Package Title : Construction of Tunneling Works including Testing and Commissioning for Double Line High Speed Railway using Tunnel Boring Machine (TBM) and New Austrian Tunneling Method (NATM) between Mumbai Underground Station at Bandra-Kurla Complex (MAHSR Km. 0.773) and Shilphata (MAHSR Km. 21.150) in the State of Maharashtra for the Project for Construction of Mumbai-Ahmedabad High Speed Rail.

Package No : MAHSR-C-2

Date: 26 - Dec – 2019

Response to Bid Queries - 6

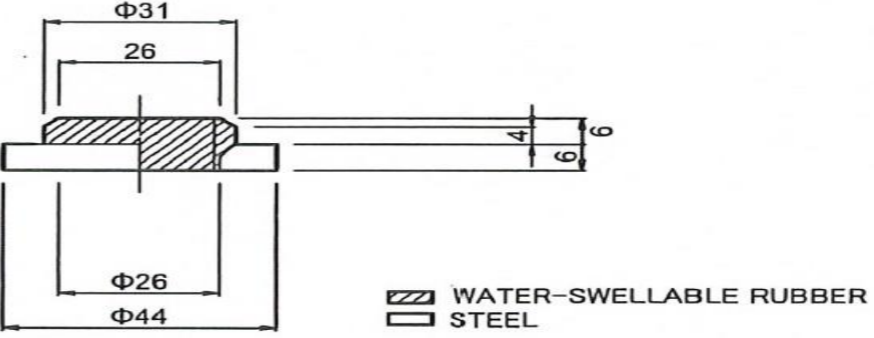
5.	Part 2 Section VI-2 Method of Measurement for Payment	Addendum 4_ Attachment 3 101 Site Offices Page 1 of 20	Partial payment on completion of site offices	<p>101 Site Offices</p> <p>Clause 101 stipulates that “Measurement for payment for this item shall be on lumpsum basis complete in all respects. The payment for the item shall be made on lumpsum basis as per price entered in the Priced Bill of Quantities.”</p> <p>Bidder interprets from the above clause 101 that providing cost of Site Offices for the Engineer / the Employer would be claimed and paid only after their demolition, which is NOT reasonable.</p> <p>Therefore, bidder requests the Employer to consider changing the conditions to allow a partial payment for 80% of the lump sum cost upon completion of the offices.</p>	Refer Addendum No. 9 Item No. 3, Sub-Clause 2.5.8.

Drawing No.	TD-JIC-IC1-TDC-B01-UST-NTU- 00400001																		
Title	PERMANENT REINSTATEMENT & ASSOCIATED WORKS (DETAIL OF BOUNDARY WALL OVER FOOTING)(1)																		
Scale	AS MENTIONED @ A1

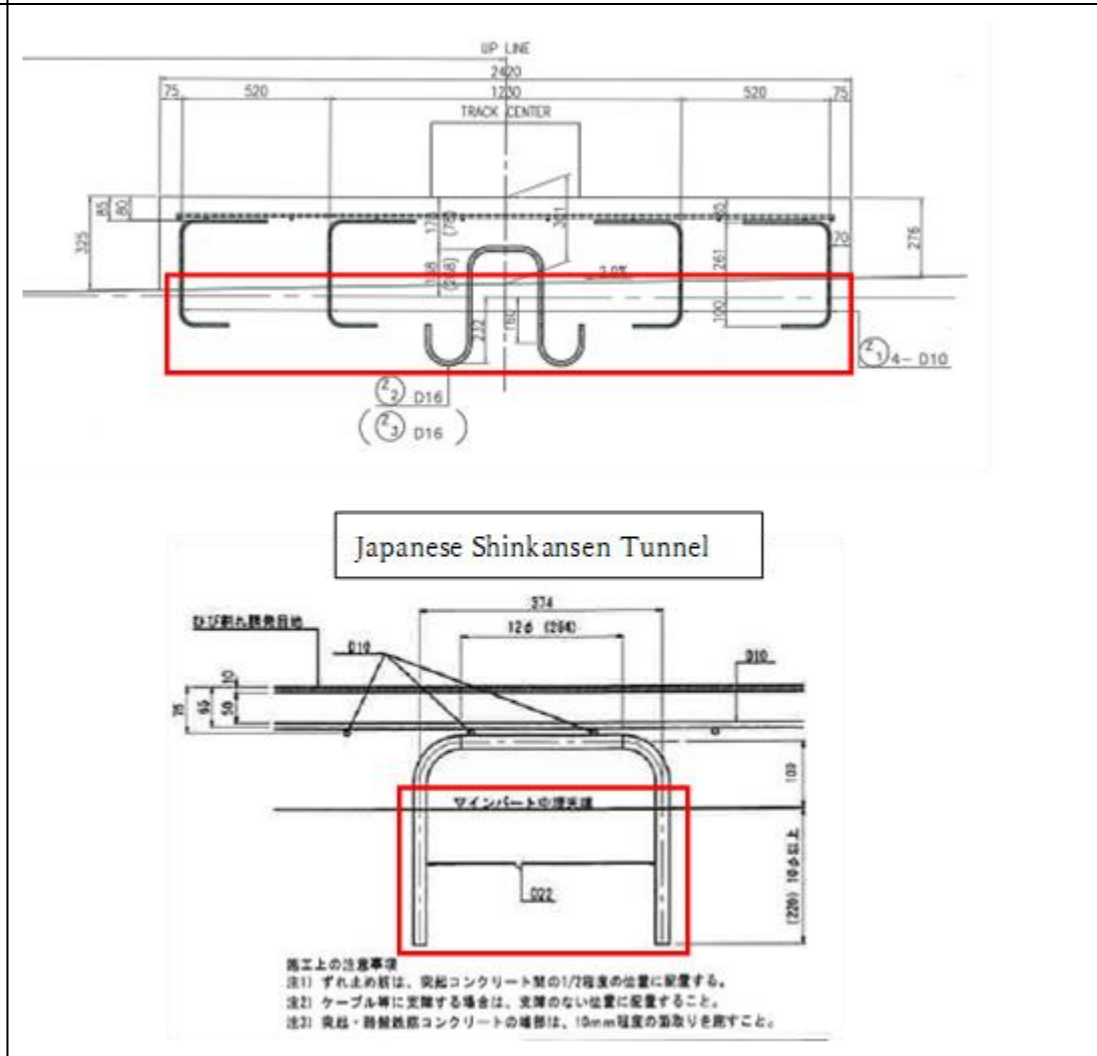
Sl. No	Document	Page no / Clause No.	Provisions as Per-Bidding Documents/Subject/Title/Item as mentioned by the Bidder	Bidder Query	Employer's Reply														
				<p>In additions to above discrepancies, revised drawings of Addendum No.6 are as follows. Please confirm correct drawing numbers.</p> <p>Addendum No. 6 Revised Drawings TD-JIC-IC1-TDC-B01-UST-NTU-00400001 TD-JIC-IC1-TDC-B01-UST-NTU-00410001 20TD-JIC-IC1-TDC-B01-UST-NTU-00420001 TDA-JIC-IC1-TDC-B01-UST-NTU-00430001 TD-JIC-IC1-TDC-B01-UST-NTU-00470001</p> <p>Typical Discrepancy of Drawing Number between Addendum No. 6 and No. 2</p> <table border="1" data-bbox="1439 829 2151 1144"> <tr><td>Adopted by:</td><td>NHSRCL</td></tr> <tr><td>Title</td><td>PERMANENT REINSTATEMENT & ASSOCIATED WORKS (DETAIL OF BOUNDARY WALL OVER FOOTING)</td></tr> <tr><td>Scale</td><td>AS MENTIONED @ A1</td></tr> <tr><td>Drawing No.</td><td>TD-JIC-IC1-TDC-B01-UST-NTU- 00400001</td></tr> </table> <table border="1" data-bbox="1439 1165 2151 1438"> <tr><td>Title</td><td>PERMANENT REINSTATEMENT & ASSOCIATED WORKS (DETAIL OF BOUNDARY WALL OVER FOOTING)(1)</td></tr> <tr><td>Scale</td><td>AS MENTIONED @ A1</td></tr> <tr><td>Drawing No.</td><td>TD -JIC -IC7 -TDC -B07 -UST -NTU-00400000</td></tr> </table>	Adopted by:	NHSRCL	Title	PERMANENT REINSTATEMENT & ASSOCIATED WORKS (DETAIL OF BOUNDARY WALL OVER FOOTING)	Scale	AS MENTIONED @ A1	Drawing No.	TD-JIC-IC1-TDC-B01-UST-NTU- 00400001	Title	PERMANENT REINSTATEMENT & ASSOCIATED WORKS (DETAIL OF BOUNDARY WALL OVER FOOTING)(1)	Scale	AS MENTIONED @ A1	Drawing No.	TD -JIC -IC7 -TDC -B07 -UST -NTU-00400000

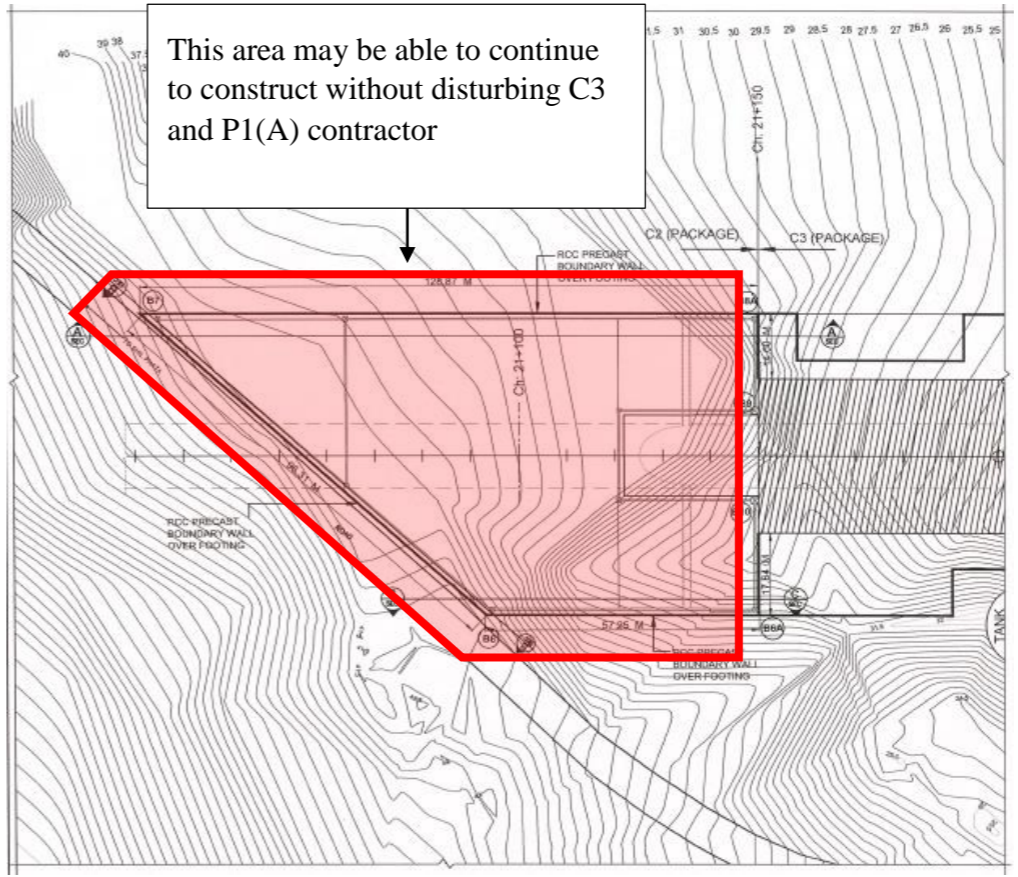
28.	Response to Bid Queries - 4 Item Nos. 9 and 18 3. NATM Drawings	TD-JIC-IC1-TDC-B01-UST-NTU-20100000	Re-instatement of BOQ item for “Grouted forepoling φ27.2 x 3.0m at NATM Tunnel”	<p>Bidder would like to draw the Employer’s attention to the following responses / clarifications regarding “grouted forepoling φ27.2 x 3.0m at NATM Tunnel”:</p> <ol style="list-style-type: none"> The Employer’s Response to Bid Queries – 4, Item No. 9 states that “Item 502 (d) (ii) has been deleted.” The Employer’s Response to Bid Queries – 4, Item No. 18 states that “Cost of auxiliary supports including forepoling are included in BOQ Item no. 501. Nothing extra shall be payable for auxiliary supports including forepoling.” The bidder’s query in Clarification No. 13, Item 2, dated 21 Aug 2019 is “Bidder noted that forepoling was deleted from BOQ 502 & 510 in Addendum No. 4 Attachment 1. Please kindly delete details of fore poling in corresponding Drawing 20100000.” <p>From the above items, bidder notes the Employer’s intentions are:</p> <ol style="list-style-type: none"> Forepoling at NATM is still required for the works and Payment for such work shall be included in BOQ Item No. 501 under auxiliary supports. <p>However, bidder considers that the work for forepoling at NATM work should be paid as a re-measurable item and bidder is unable to price for this item in BOQ</p>	The condition(s) of Bidding Document remains unaltered.

Item No. 501 as there are no details like location of application and nos. required. Therefore, in order to apportion the fair share of risks among the parties involved and thus reduce the total project cost by eliminating unnecessary additional cost for contingency, the bidder would like to request the Employer to consider re-instating an item in the BOQ for "Grouted fore poling $\phi 27.2 \times 3.0\text{m}$ at NATM Tunnel".

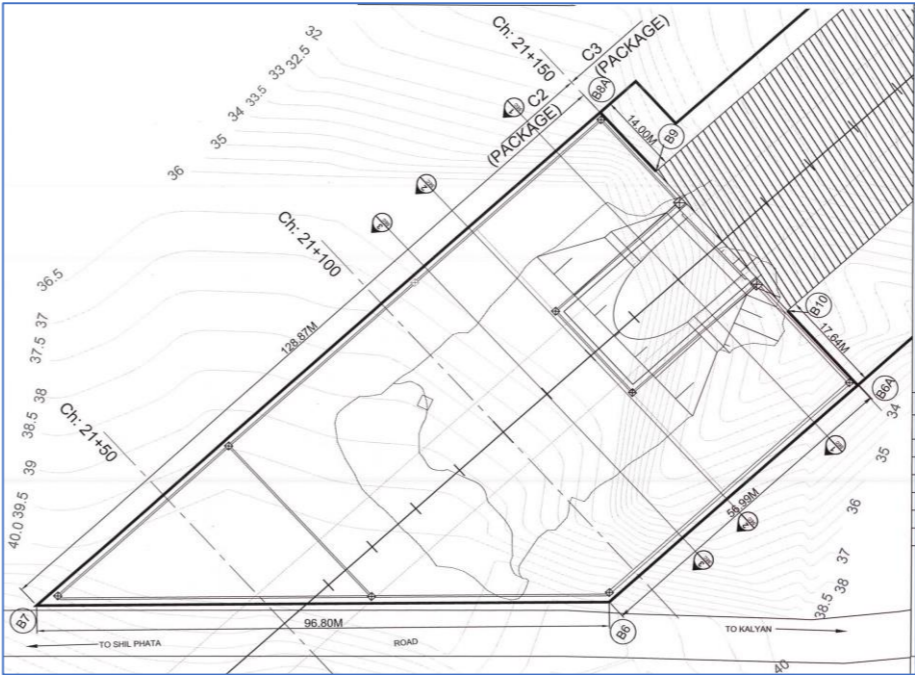
30.	Response to Bid Queries 5 – 09102019	<u>For Item 7 of CL9</u> Drawings from Tender Documents 6. TRACK BED Drawings <u>For Item 10 of CL9</u> Drawings from Addendum #2 C. SHAFT-2 DRAWINGS	Outstanding Items 7 and 10 of Clarification 9 dated 25 July 2019 <u>For Item 7 of CL9</u> Lack of drawings for Track Bed Rebar and Dowel Anchor 2019 <u>For Item 10 of CL9</u> Request additional information on the drawing.	Bidder acknowledges that the Employer's Response to Bid Queries 5 has covered all items up to Clarification 14 dated 02 Sep 2019 except 2 items of Clarification 9 as listed below (without drawings): 1. <u>Item 7 of CL9</u> j. There are 14 types of Track Bed in the bidding document but only 2 types of Track Bed's Rebar arrangement and Dowel Bar drawings are provided in the bidding document. Please provide us the Bar arrangement and Dowel Bar drawing for the remaining 12 types of track bed. 2. <u>Item 10 of CL9</u> (1) <u>Drawing 15010001 / STRUCTURE DETAIL OF SHAFT-2 (1)</u> k. Drainage Ditch does not stipulate on the drawing whilst similar structure of Shaft-3 stipulated the Drainage Ditch (see below item 2). 1. Please confirm no Drainage Ditch at Shaft-2. (2) <u>Drawing 17010001 / STRUCTURE DETAIL OF SHAFT-3 (1)</u>	Refer Addendum No 9 Item No 1.

Sl. No	Document	Page no / Clause No.	Provisions as Per-Bidding Documents/Subject/Title/Item as mentioned by the Bidder	Bidder Query	Employer's Reply																																																					
		TD-JIC-IC1-TDC-B01-UST-NTU-15010001 (REVISED) and D. SHAFT-3 DRAWINGS TD-JIC-IC1-TDC-B01-UST-NTU-17010001 (REVISED)		<p>m. Drainage Ditch stipulated in Sections. However, it does not stipulate in Slab Sections. (see Below typical part copy of drawing.)</p> <p>Please provide detailed information of the Drainage Ditch including outlet (e.g. discharge pipe).</p> <p>Please provide replies to the above 2 items soonest possible.</p>																																																						
31.	Part 1 Section IV Bidding Form	Pages 8 & 9 of 159	(F) Schedule of Adjustment Data Table A. Local Currency	<p>Reference is made to Table A below:</p> <p style="text-align: center;">Table A. Local Currency</p>
